**Re: Dominican Valley Residential Development Applications –
Inapplicability of Builder’s Remedy**

**Re: File No: PA23-002 (PLAN23-075)
Preliminary Application for Dominican Residential Development - Proposal A
(APN 015-163-03)**

SUBJECT: Planning File #PLAN23-075 – Pre-Application: 29 Units Dominican Site (a)

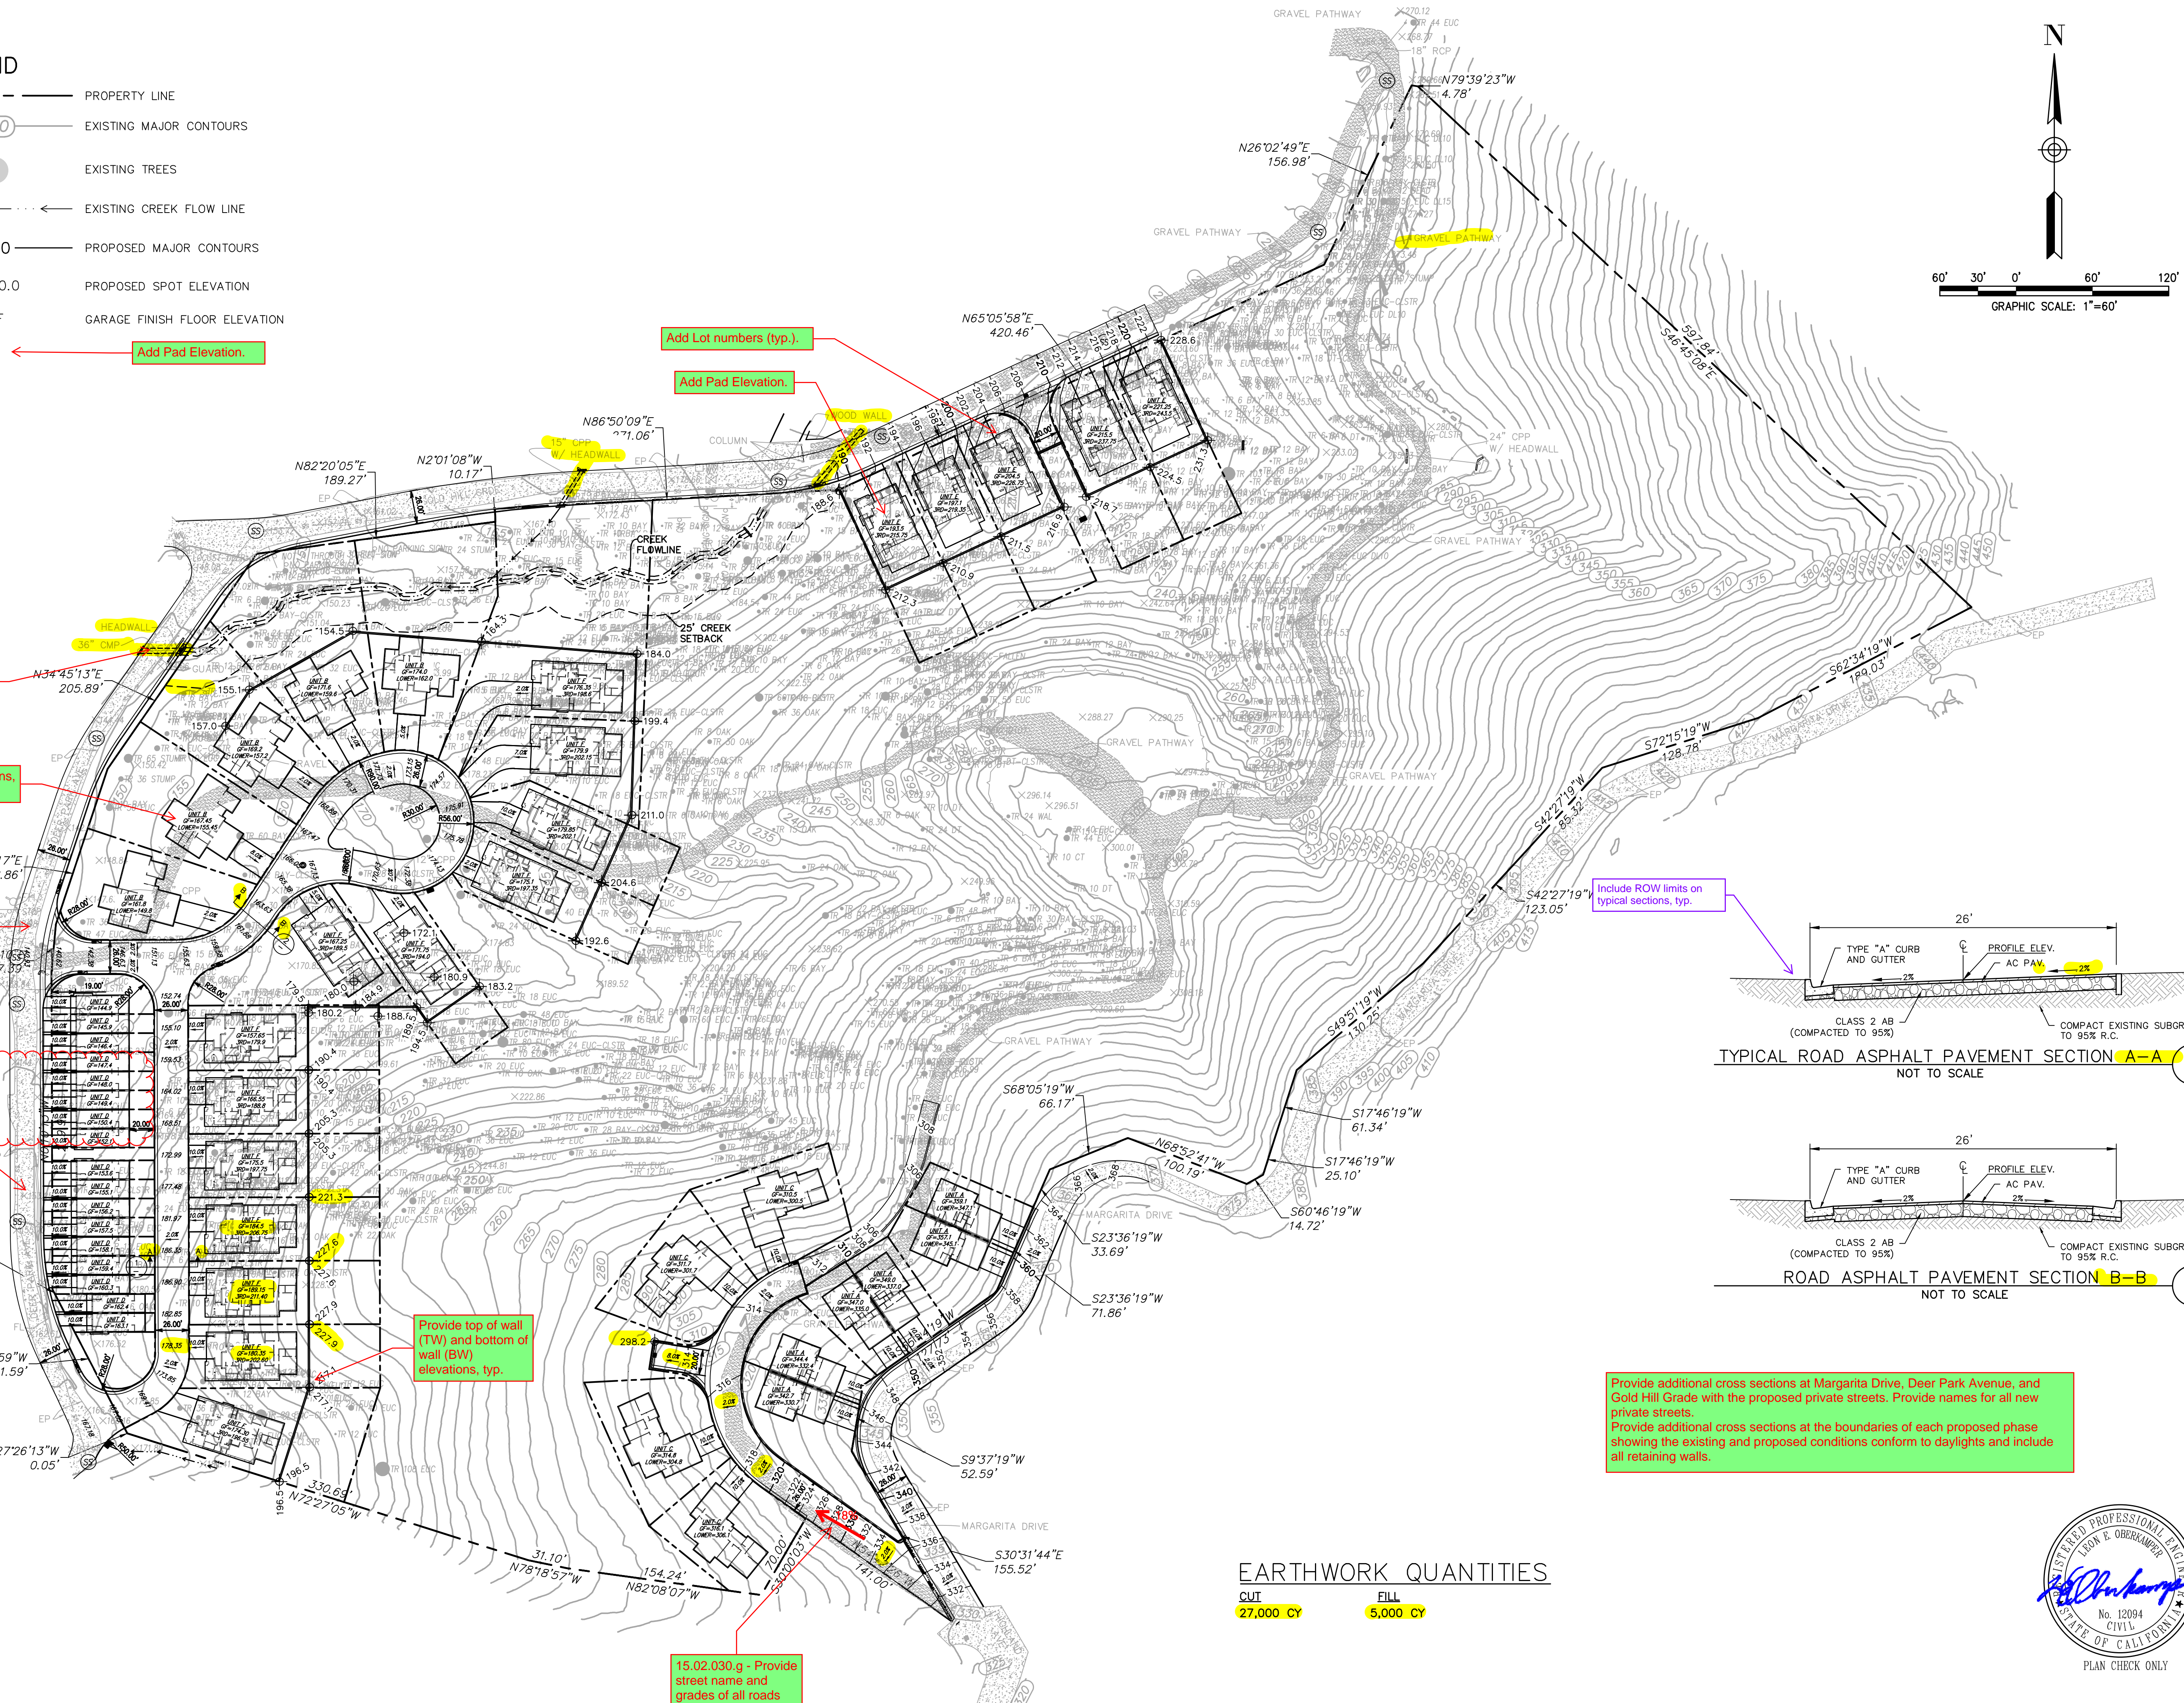
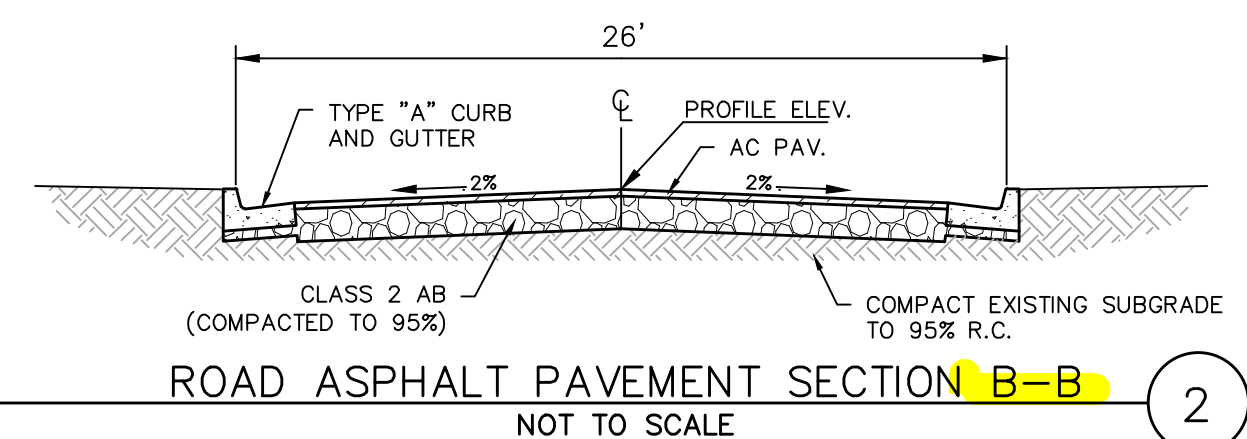
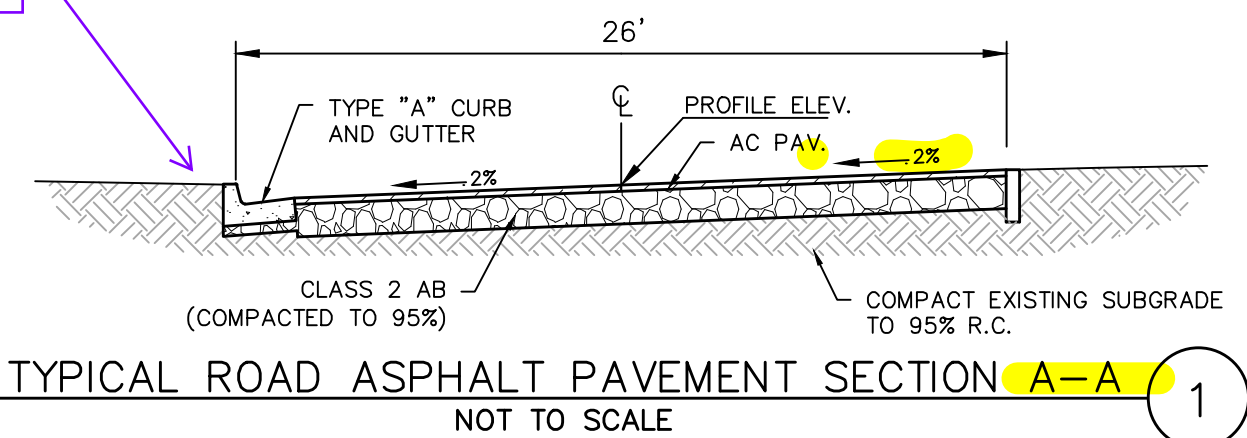
Provide details for all culverts being up-sized to handle the 10-year design storm, typ.

Add Pad Elevations, typ.

Provide section for Deer Park Ave and Gold Hill Grade

Please provide cross sections through the multifamily homes and Deer Park Avenue to clarify conform between existing infrastructure and proposed improvements.

Provide additional cross sections at Margarita Drive, Deer Park Avenue, and Gold Hill Grade with the proposed private streets. Provide names for all new private streets. Provide additional cross sections at the boundaries of each proposed phase showing the existing and proposed conditions conform to daylight and include all retaining walls.

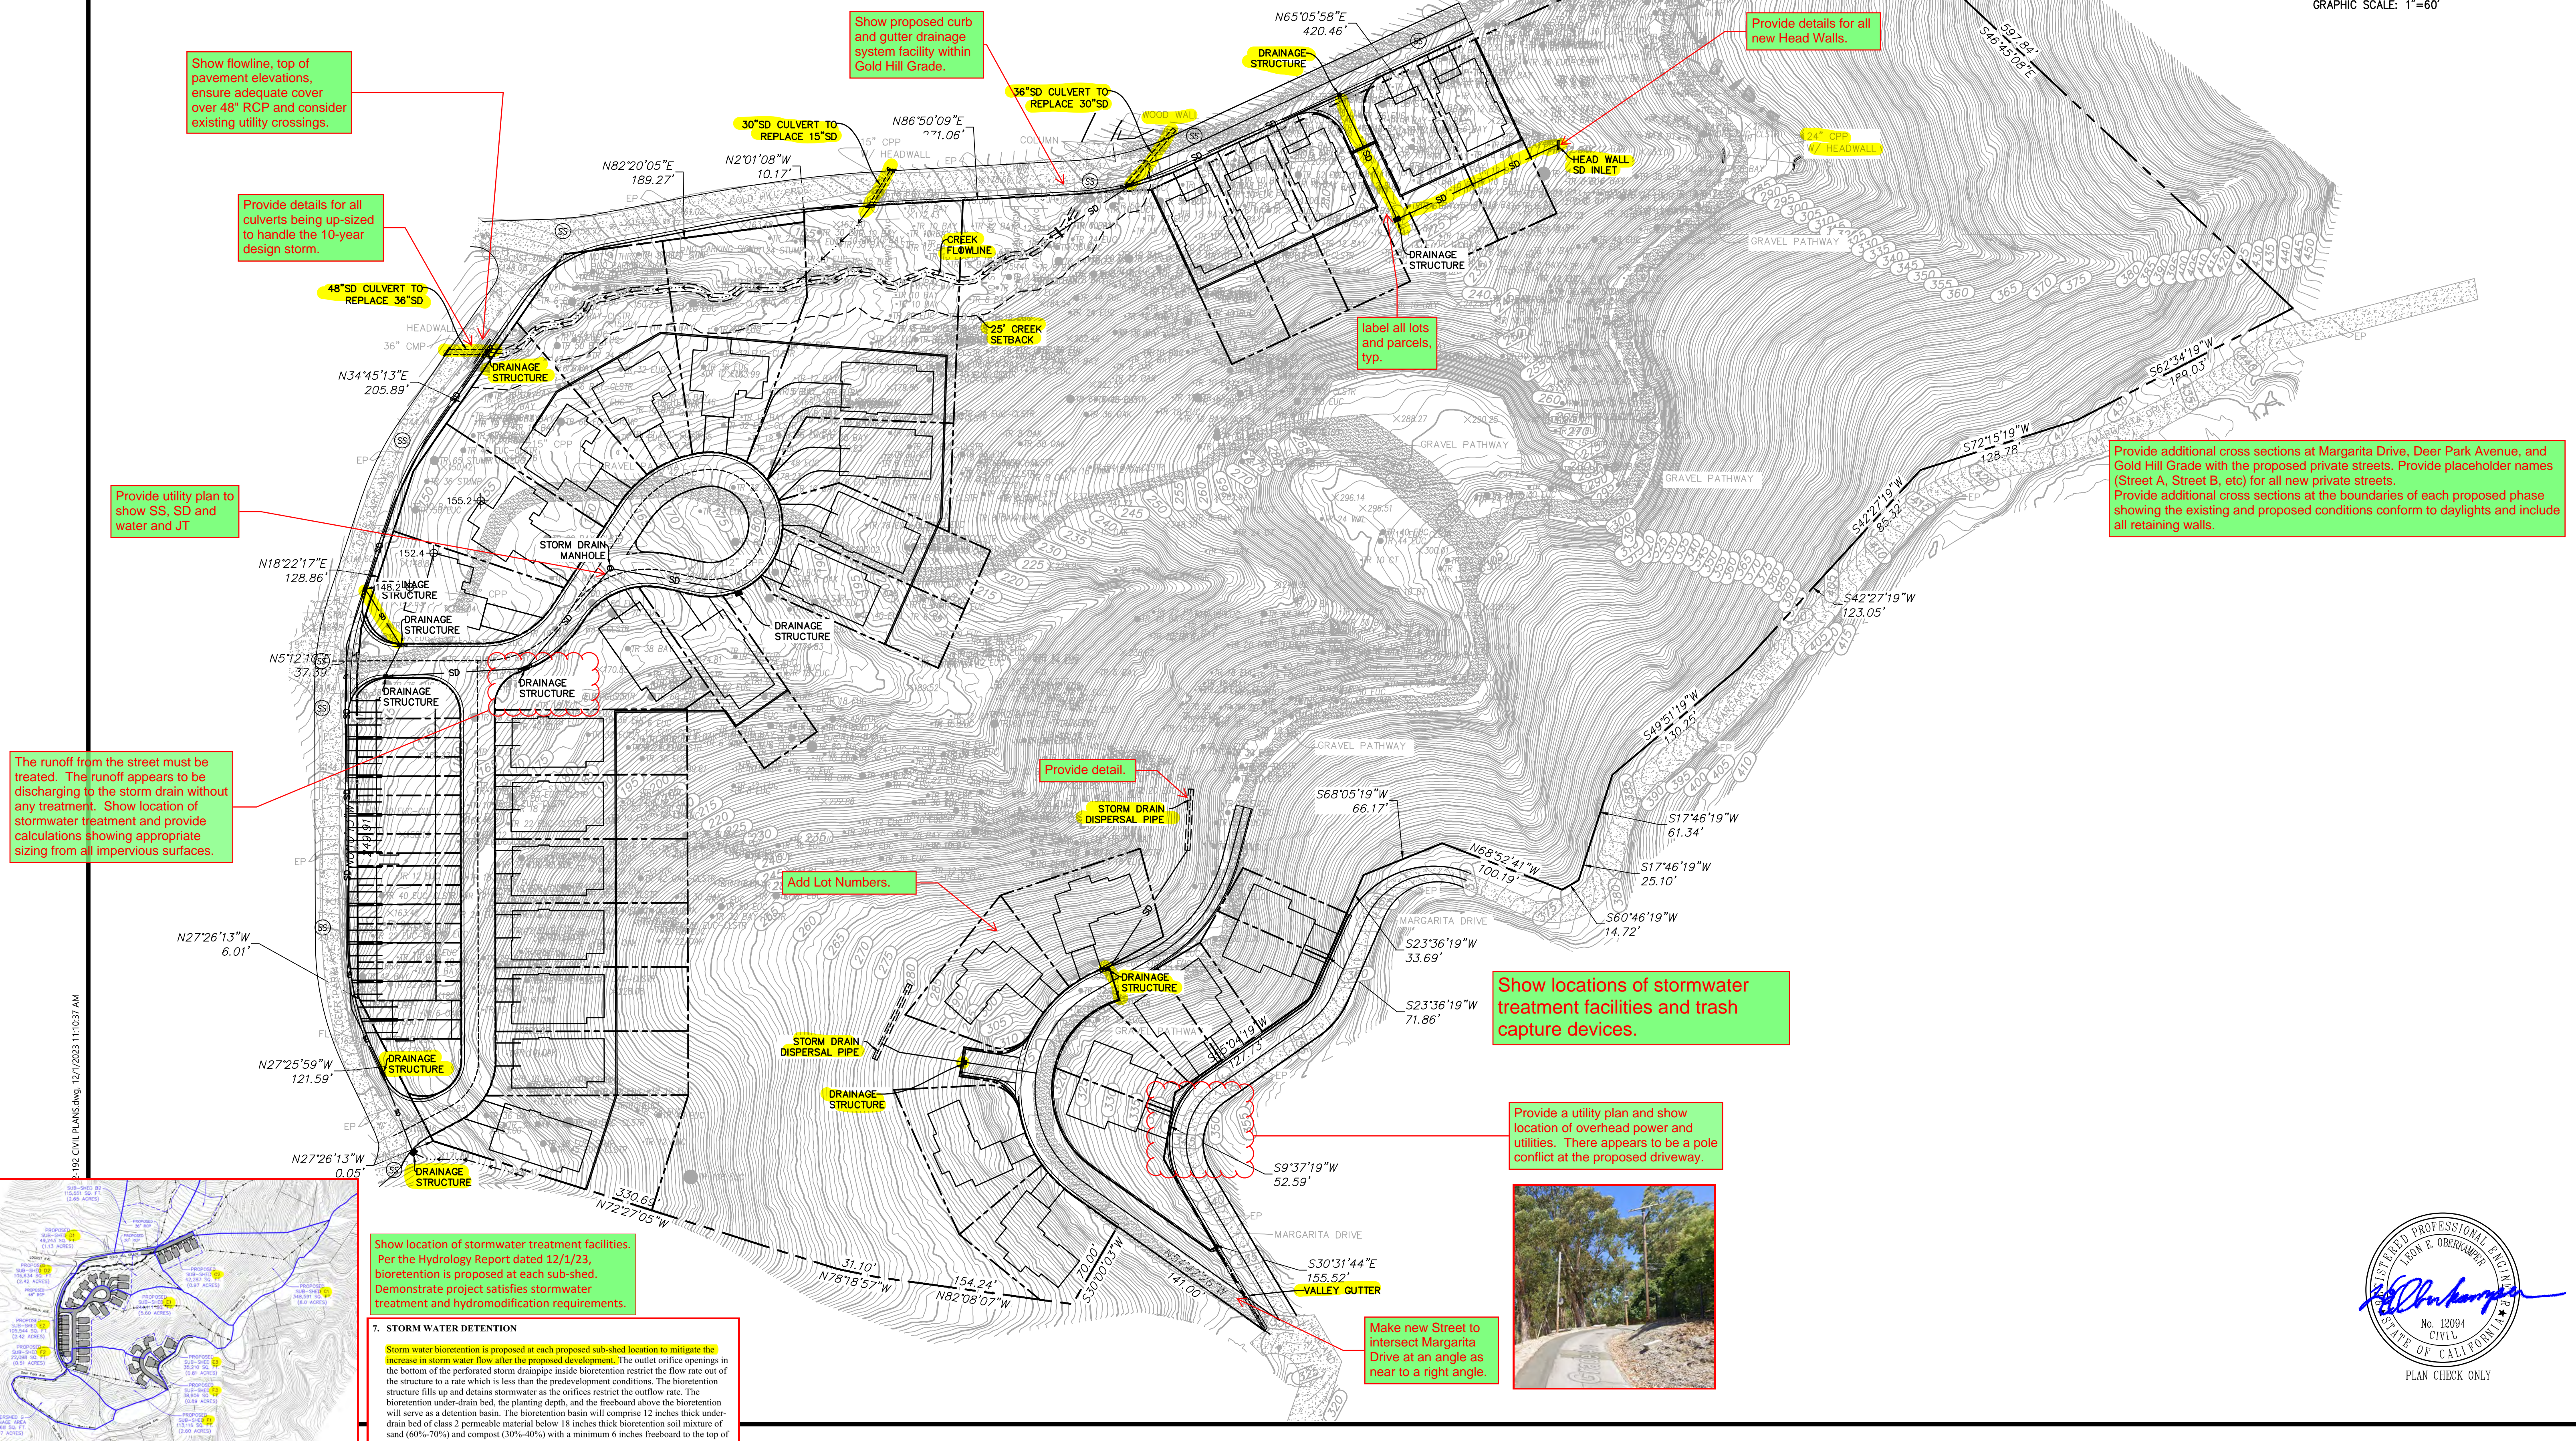
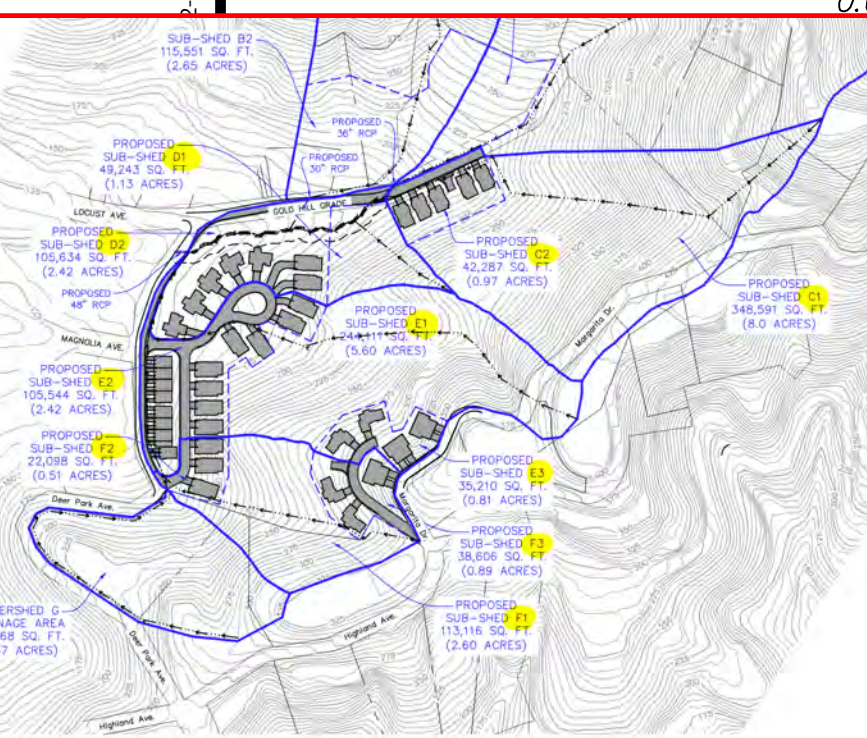
Show flowline, top of pavement elevations, ensure adequate cover over 48" RCP and consider existing utility crossings.

Provide detail.

Add Lot Numbers.

Show locations of stormwater treatment facilities and trash capture devices.

Provide a utility plan and show location of overhead power and utilities. There appears to be a pole conflict at the proposed driveway.
